# **FIRE SAFETY INSPECTION REPORT**

**SHANTA DENIMS LTD**

April 30, 2014

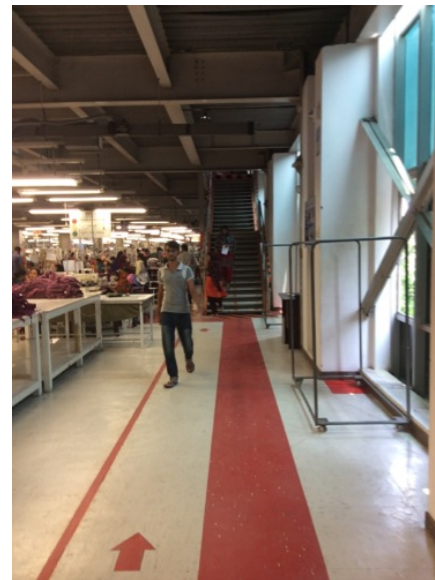
| F-6 | Fire Rated Construction | Exit stair is not enclosed with fire-rated construction in the middle of the building | Enclose the exit stair with fire-rated construction. | Within 3 months |
